SITE PLAN - OPTION FOUR
1" = 20'-0"

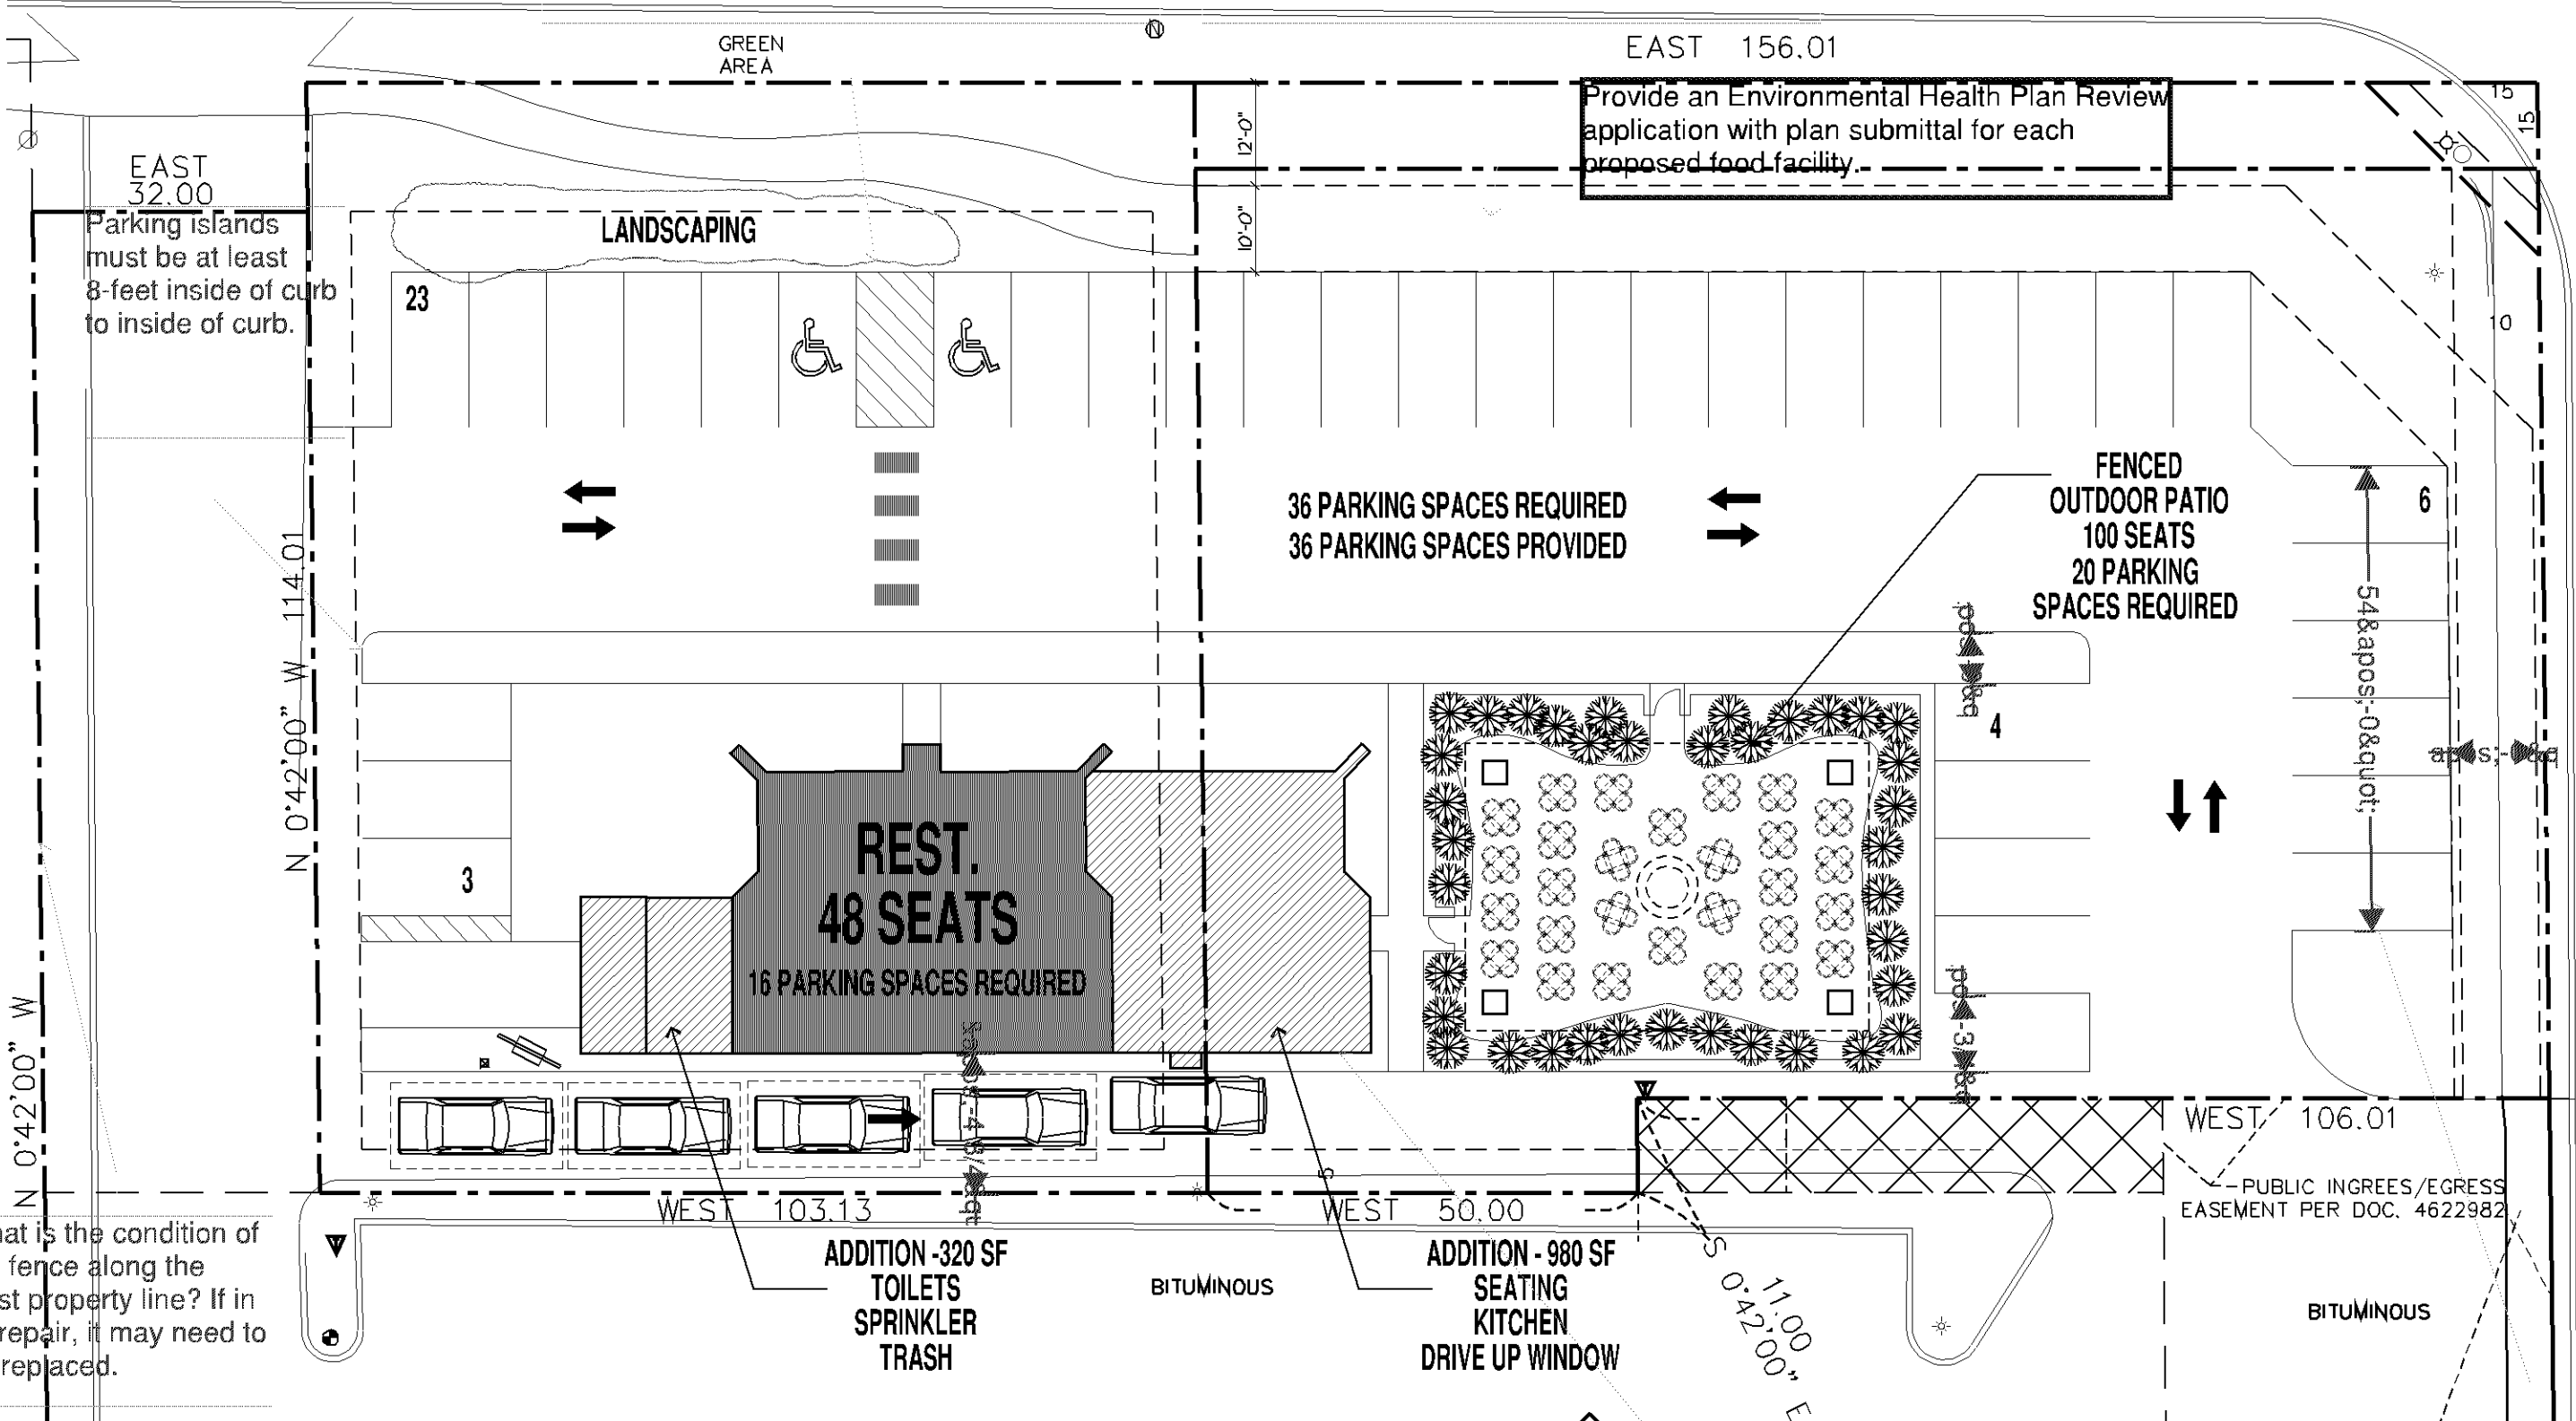
Per 1306, with the addition to the restaurant, the building will be required to be sprinklered and a code complying monitored fire alarm system.

The kitchen hood(s) shall be protected by a UL listed and code complying system connected to the building sprinkler system.

Provide emergency vehicle access and circulation for ladder 3.

Ensure hydrant coverage within 150' of exterior walls of the building.

Show the sidewalk impacts along 90th St and Penn Ave. It's hard to tell what will be impacted with this redevelopment.

Include a sidewalk connection to accessible stall striping.

Include the Code required 8-foot concrete sidewalk along 90th and along Penn.

What is the condition of the fence along the west property line? If in disrepair, it may need to be replaced.

Could the eastern most stalls along Penn be shifted west to accommodate a wider landscaping yard?
